Ref: 6129

## LEESTON PLAN CHANGE - RFI RESPONSE

Thank you for your letter dated 19 September requesting further information regarding Plan Change PC190062: Private Plan Change Leeston. Baseline Group has prepared the following response.

# NW Leeston - 200 year flood model results

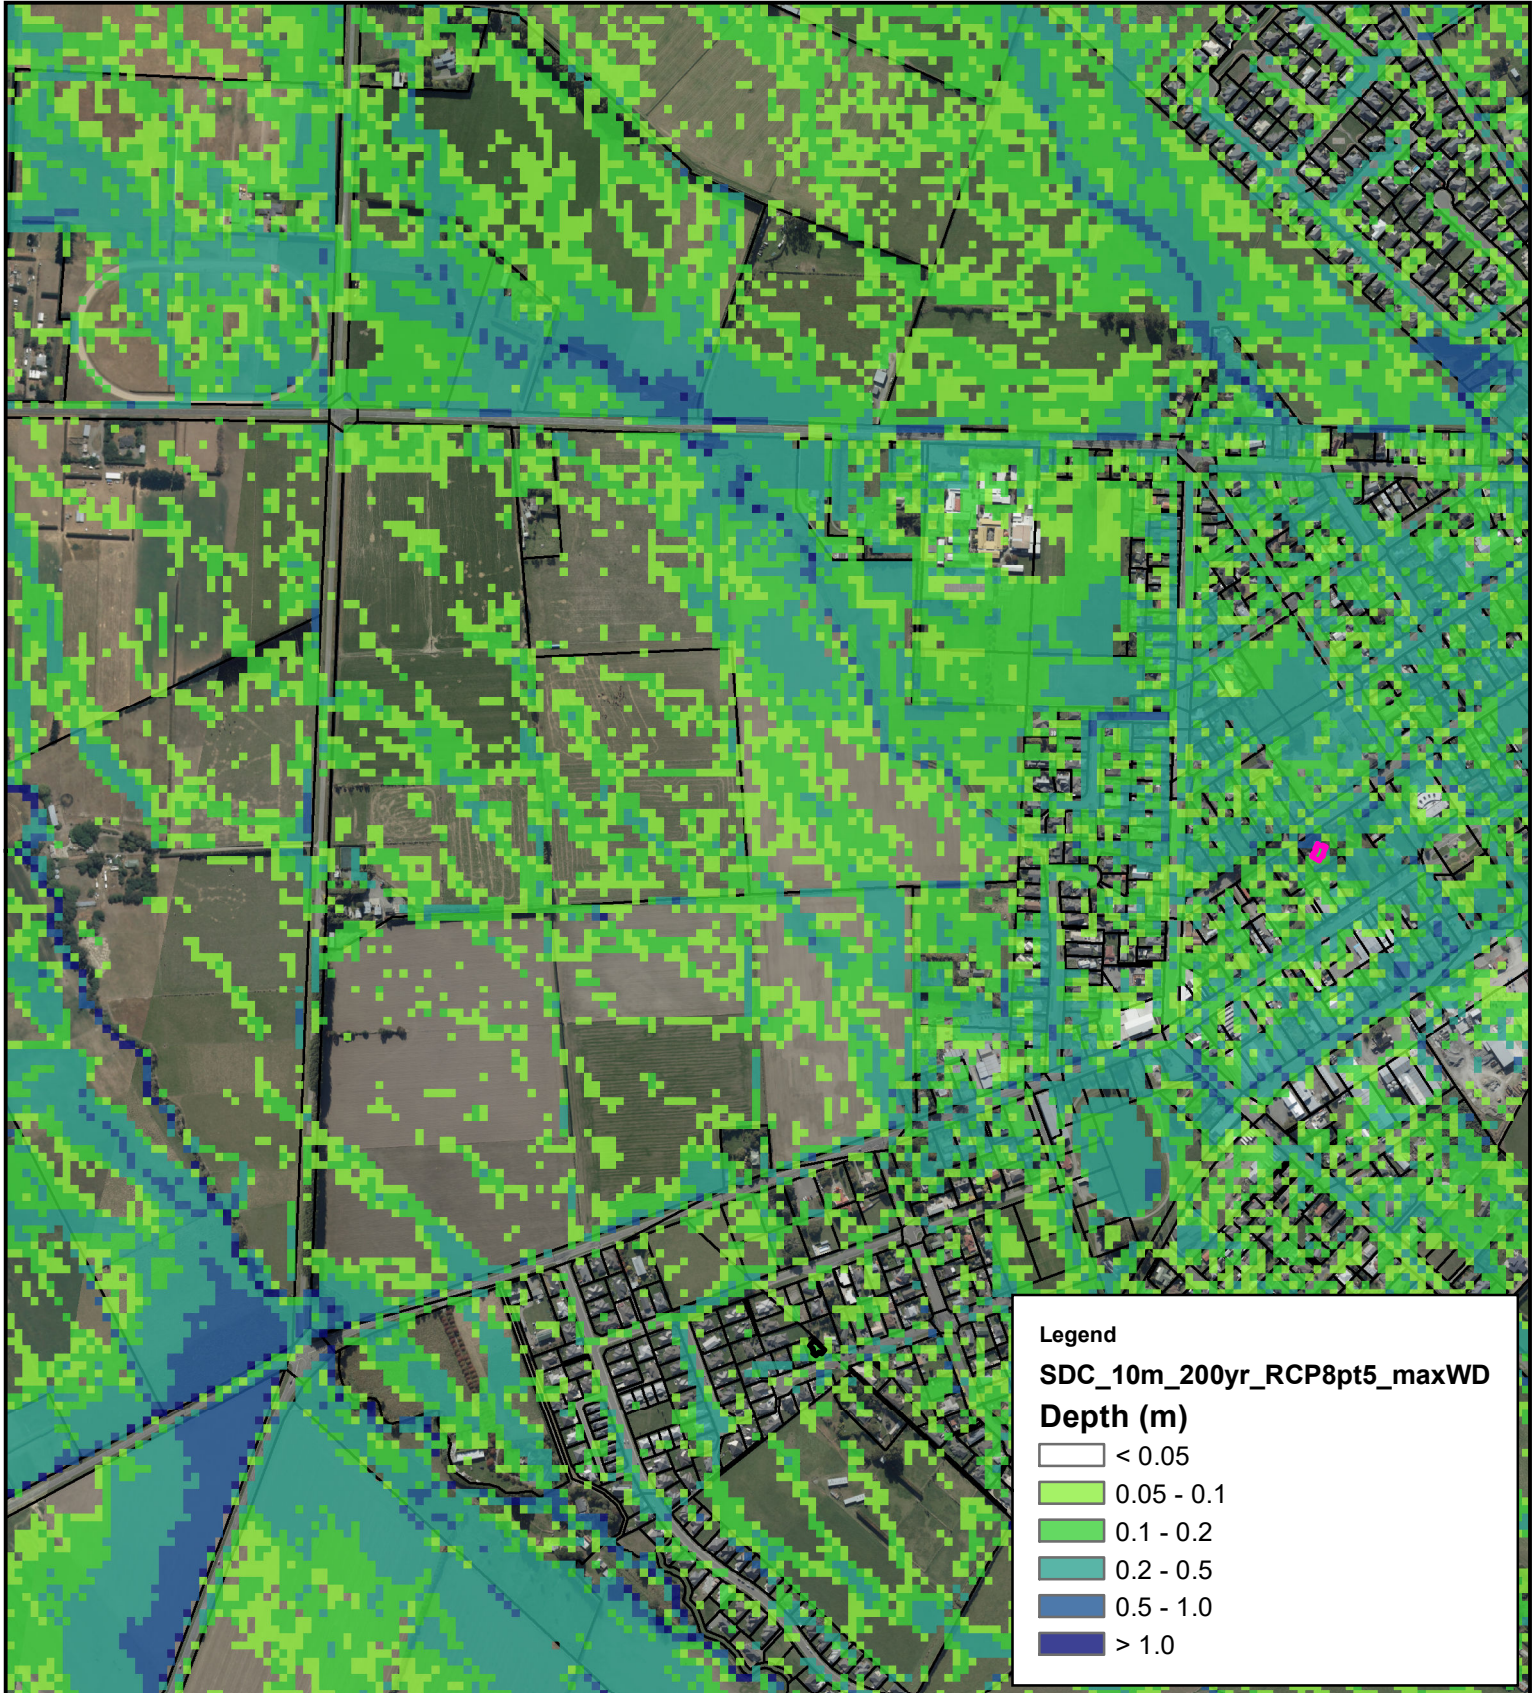
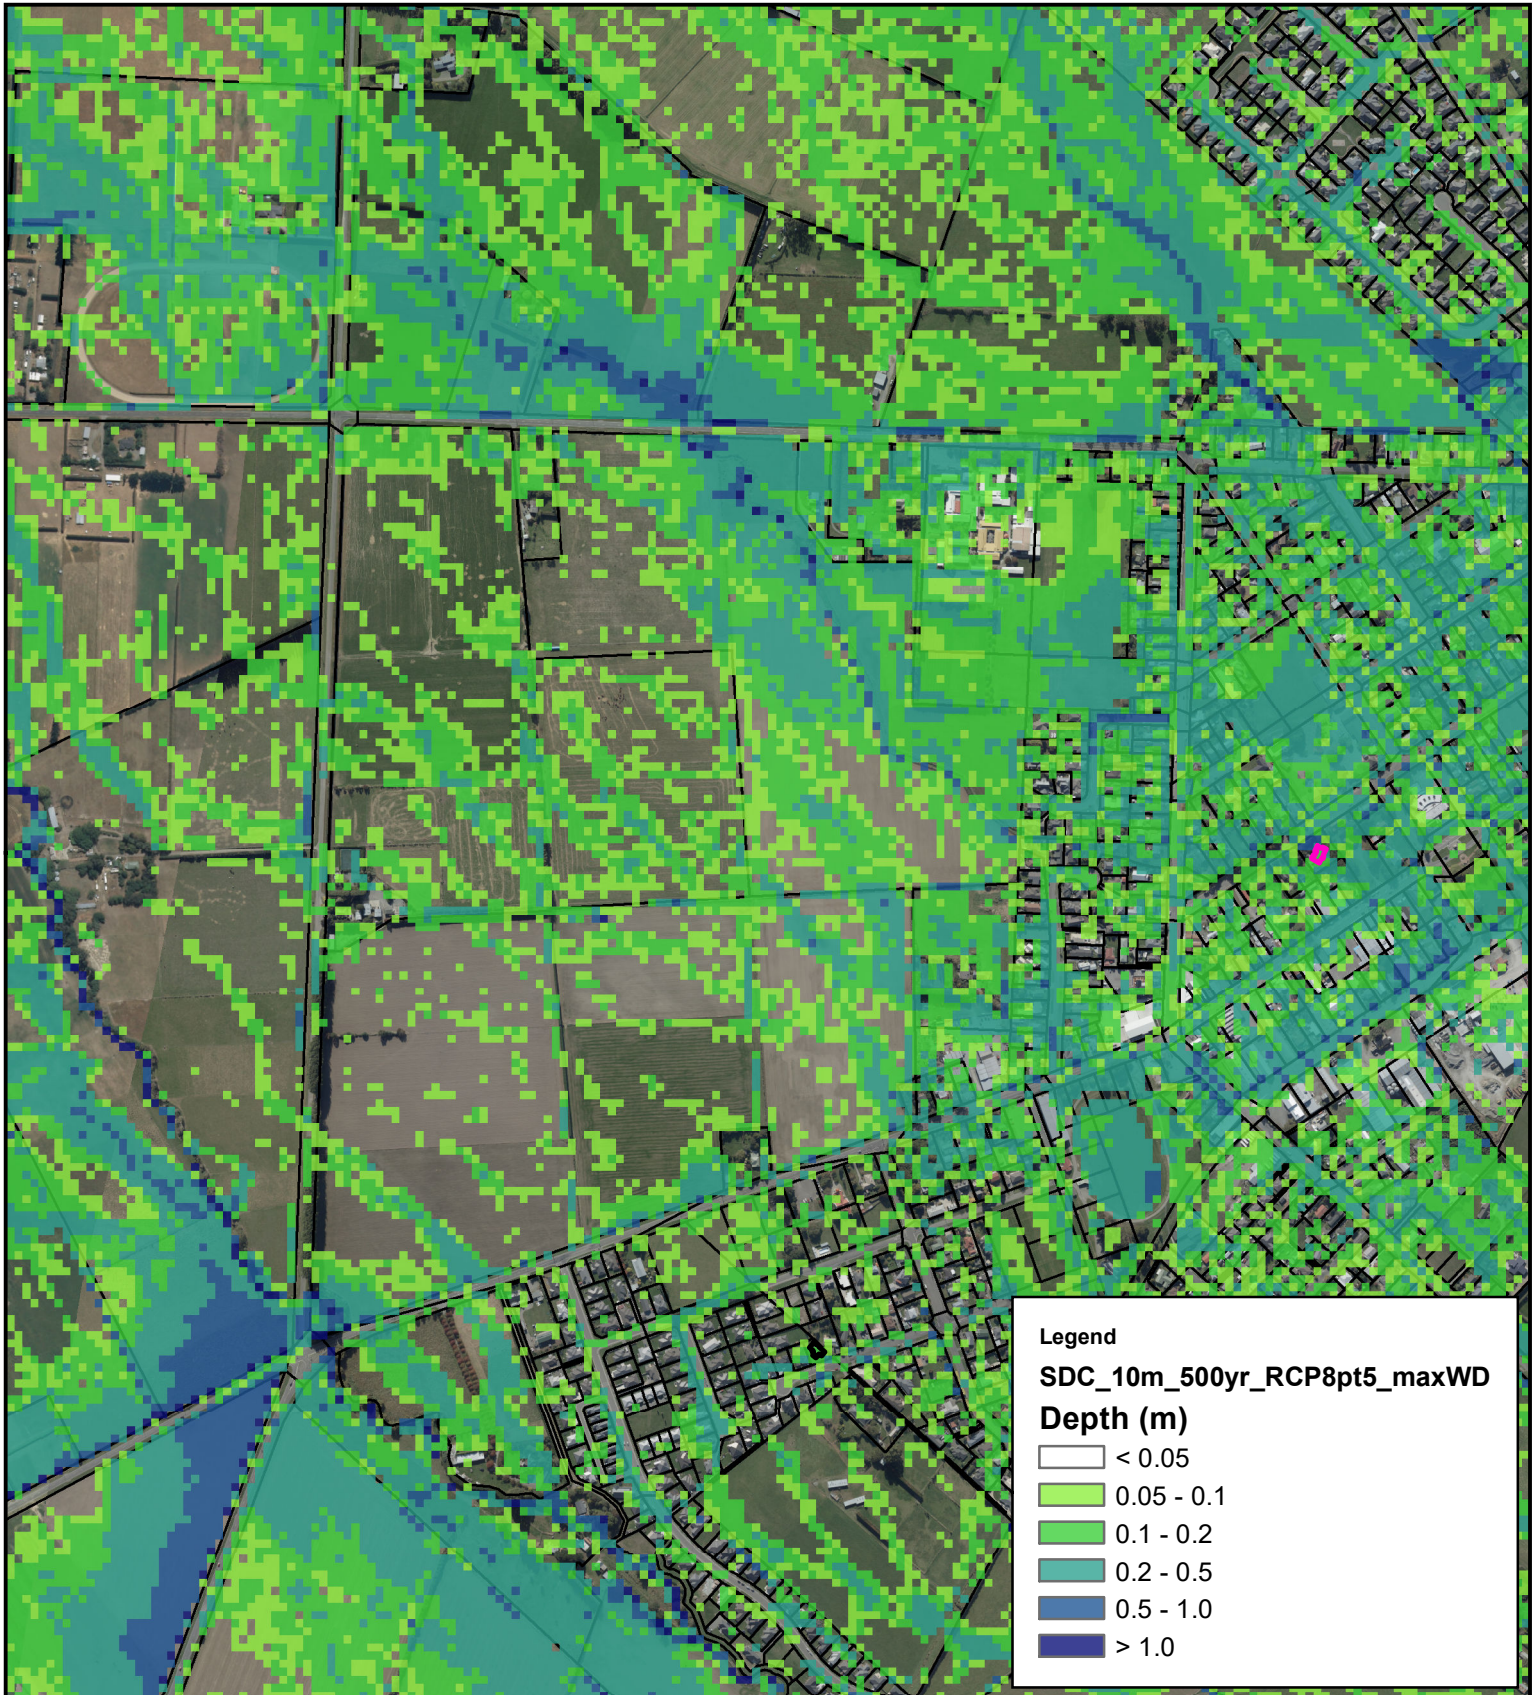
4. *Please confirm that the 2015 LiDAR data provided in Appendix 6 is the latest data available, and that the balance of the advice from Environment Canterbury in 2017 is still current.*

ECan have confirmed the 2015 LiDAR data is the most up to date. Email confirmation is attached to this letter in Appendix 1. In addition, ECan have provided the draft results from flood modelling of the 200 and 500 year return period (0.5 and 0.25% AEP), which are also attached in Appendix 1. Note these are draft versions and final results of the modelling have not been released.

The results of the draft modelling show parts of the plan change site being subject to surface flooding and provides evidence of specific areas within the plan change site that are more susceptible to flooding and ponding. This information is helpful to Council and any future developer of the site as it shows the areas that are not affected by the 200 year flood event which could be developed first and before the stormwater bypass is constructed. It shows there are areas in the plan change site that could be developed and would not be subject to inundation in flood events.

As discussed on the phone, the 2015 LiDAR is the most up to date LiDAR

I have attached two maps showing flood depths for a modelled 200 and 500 year return period district wide rainfall runoff event.

Note that these are results from draft modelling commissioned by Selwyn District Council, and this is not published information. Based on my ongoing involvement in calibrating this modelling, I would suggest that the final results are unlikely to change dramatically at this location.

**Figure 1: 2019 Peak Hour Traffic Volumes at Market Street / High Street Intersection**

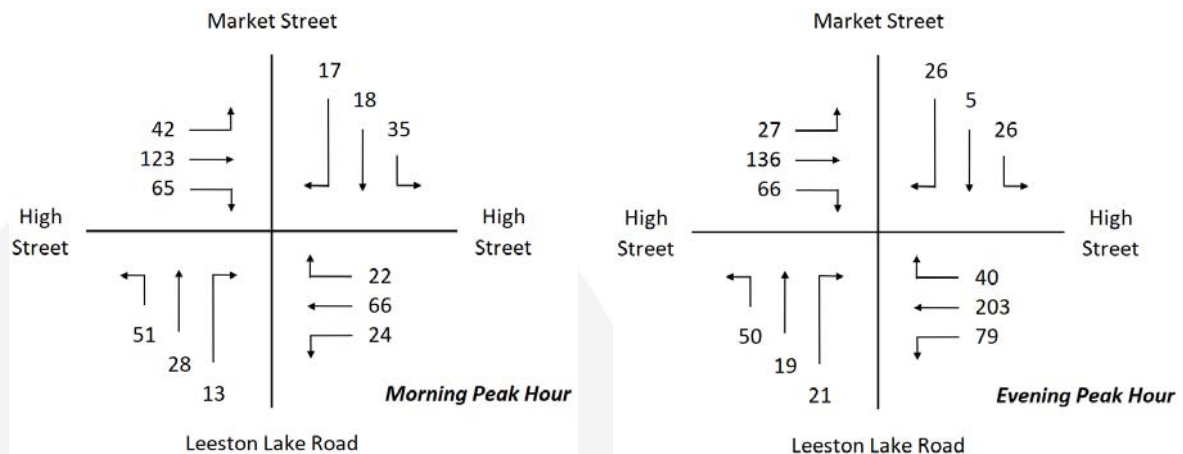
9. *The Transportation Assessment does not provide a level of service assessment of the Market Street/High Street intersection resulting from the likely increase in traffic from the west (and likely north from Leeston Dunsandel Road) as a result of the proposed plan change. There are presently concerns within the community regarding the existing level of traffic using this intersection. Therefore, given that the Transportation Assessment indicates that there will be a significant increase traffic volumes east along High Street, the assessment needs to be extended to cover the Market Street/High Street intersection and any issues identified need to be addressed, to allay or mitigate these issues.*

In the Transportation Assessment, we noted that the traffic volumes generally fell below the threshold at which a formal intersection assessment was justified, even with the plan change area fully developed. However in view of the RFI, we have undertaken a more detailed assessment of the Market Street / High Street intersection.

To determine the existing traffic volumes, we surveyed the intersection during October 2019, and the results are shown below.

By way of a check, in the Transportation Assessment we identified that the traffic flows on High Street (west) were expected to be around 610 vehicles in the peak hour. The survey showed 508 vehicles in the peak hour, indicating that the Transportation Assessment used conservatively high values.

Figure 2: Traffic Generation from Plan Change Area onto Feredays Road (No Spring Place Access)

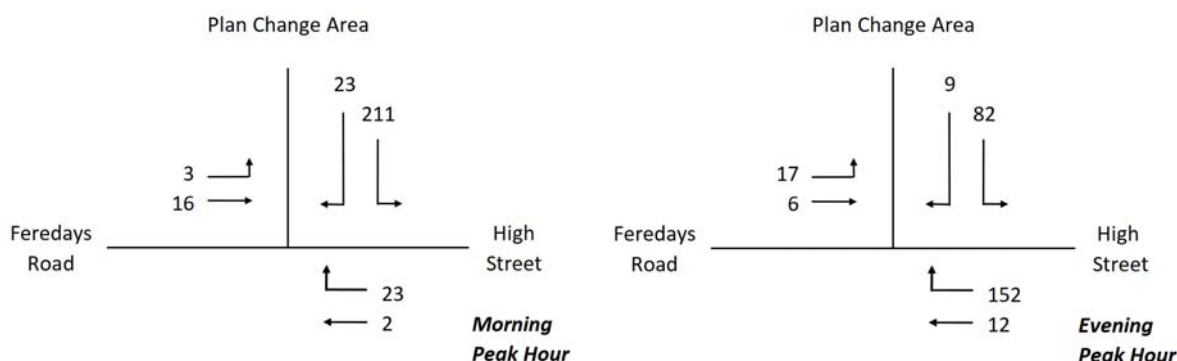
10. *A key transport connection relies on access to Spring Place. It is noted that not all land owners affected by the proposed plan change are party to the plan change, particularly the owners of Lot 3 DP 50527, being that portion of the site fronting Spring Place. Given that this is shown as an indicative primary road, what contingency is in place if this connection cannot be secured?*

The RFI queries the contingency plan if the connection through to Spring Place cannot be formed.

The Outline Development Plan (ODP) has been amended so that the secondary road is not located in the legal boundaries of Lot 3 DP 50527. Therefore, should this allotment not be developed, vehicles are able to utilise the primary roads to access the site, rather than the connection with Spring Place.

The traffic response (Appendix 2) includes an assessment of the vehicle movements should the connection to Spring Place cannot be secured and concludes that the intersection of High Street and the Plan Change area would function at a Level of Service A category in the morning and evening peak hours.

One outcome of this is that this intersection would experience a greater traffic flow than set out in the Transportation Assessment (where some traffic used Spring Place). For completeness we have shown the expected traffic flows below (with full development of the plan change area):

The intersection provides an excellent level of service with low queues and delays, even under the expected traffic loading. In the event that the intersection was to be a roundabout (as we understand has been suggested), queues and delays would remain similarly small.

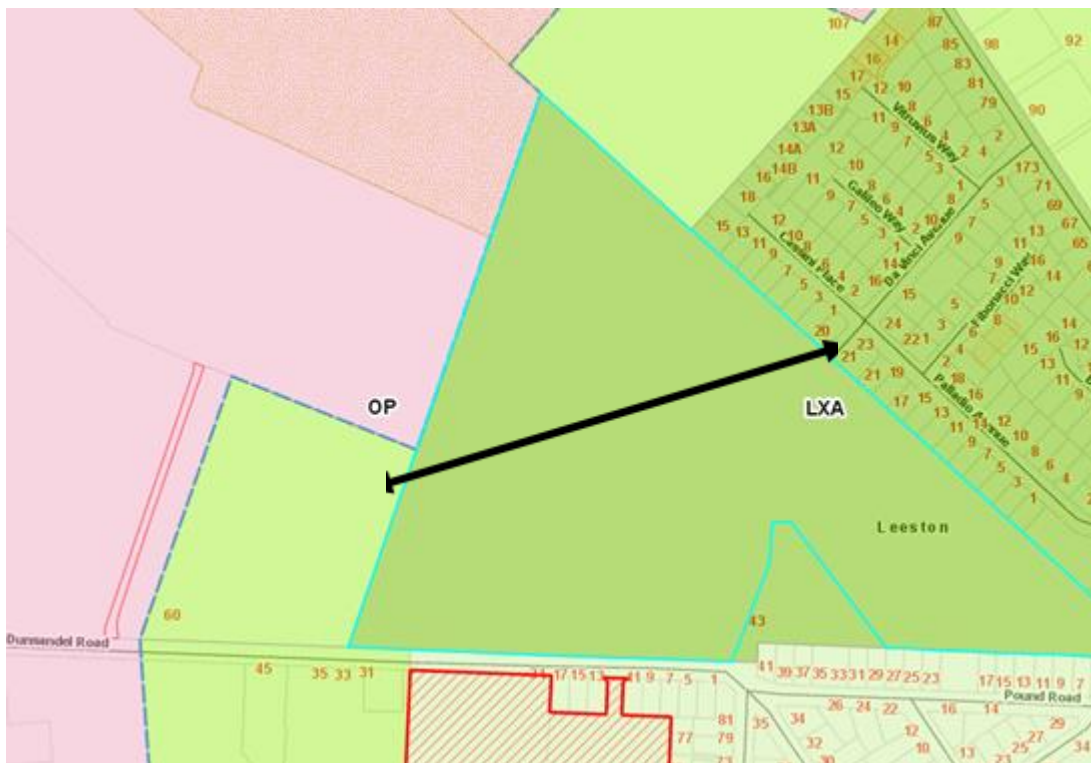
11. While a future roading connection is shown from the northern part of the site to the east, into the adjoining land known as the 'Martin Block', the approved plan of subdivision for the 'Martin Block' does not appear to allow for this. Similarly, the indicative plan of subdivision included in the Transportation Assessment also does not appear to provide for this. As such, access to the northern block would likely operate as a cul de sac, the overall length of which is inconsistent with the provisions of the operative district plan. Please provide an alternative road layout for the northern portion of the site that would increase the resilience of the network, should one access be blocked for any reason.

While the above question refers to the subdivision plan for the 'Martin Block' (subdivision consent RC 065414, and application for extension of time RC 135022), Council have confirmed this consent has lapsed (Appendix 3). Therefore, the possible future roading connection in the northern part of the site can be retained and any future development of the Martin Block should connect with the ODP.

The request for further information dated 19 September 2019 requested that the transport network be reviewed in relation to the northern block, to increase the resilience of the network. Flexibility now exists to allow for a connection to the east, such that the northern block of the proposed plan change area provides for an opportunity to link through this area, over the Martin Block to Da Vinci Avenue further east, as shown below.
